UNITED STATES
DEPARTMENT OF THE INTERIOR
BUREAU OF LAND MANAGEMENT

FORM APPROVED
OMB NO. 1004-0137
Expires: January 31, 2018**SUNDRY NOTICES AND REPORTS ON WELLS**
*Do not use this form for proposals to drill or to re-enter an abandoned well. Use form 3160-3 (APD) for such proposals.*5. Lease Serial No.
NMLC067968

7. If Unit or CA/Agreement, Name and/or No.
89100849108. Well Name and No.
WDQSU 739. API Well No.
30-025-29970-00-S110. Field and Pool or Exploratory Area
DOLLARHIDE11. County or Parish, State
LEA COUNTY, NM**SUBMIT IN TRIPLICATE - Other instructions on page 2**

**WELLBORE DIAGRAM
WEST DOLLARHIDE QUEEN SAND UNIT #73**

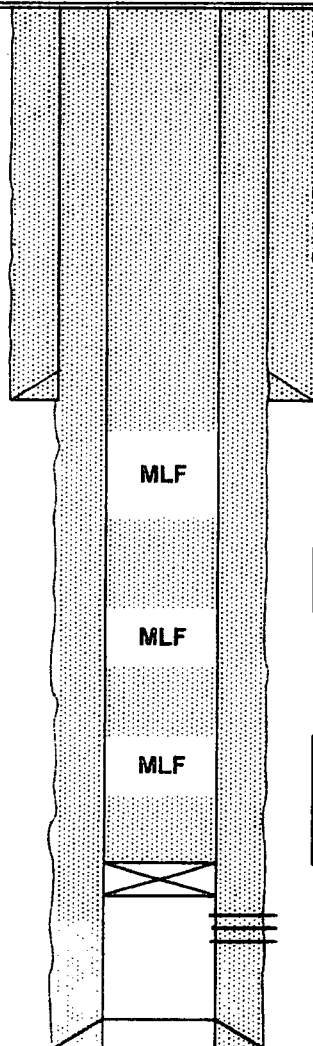
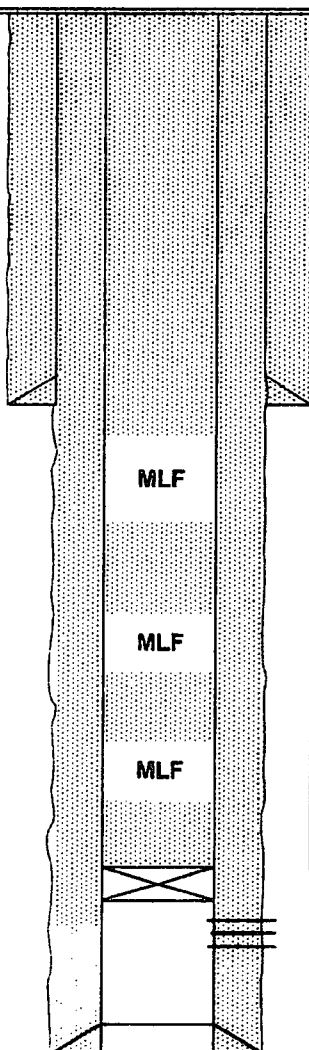
**** BLM REVISED ** BLM REVISED ** BLM REVISED ** BLM REVISED ** BLM REVISED ****

**SPOT 50SX OF CMT FROM 453'-SURFACE.
VERIFY. (FW/SHOE/SURFACE)**

**SPOT 25SX OF CMT FROM 1256'-1056'.
WOC&TAG. (T.SALT)**

**SPOT 40SX OF CMT FROM 2755'-2425'.
WOC&TAG. (YATES/B.SALT)
SET CIBP@3525' AND SPOT 20SX ON TOP
FROM 3525'-3325'.(PERFS)**

**SPOT 50SX OF CMT FROM 453'-SURFACE.
VERIFY. (FW/SHOE/SURFACE)**

**SPOT 25SX OF CMT FROM 1256'-1056'.
WOC&TAG. (T.SALT)**

**SPOT 40SX OF CMT FROM 2755'-2425'.
WOC&TAG. (YATES/B.SALT)
SET CIBP@3525' AND SPOT 20SX ON TOP
FROM 3525'-3325'.(PERFS)**
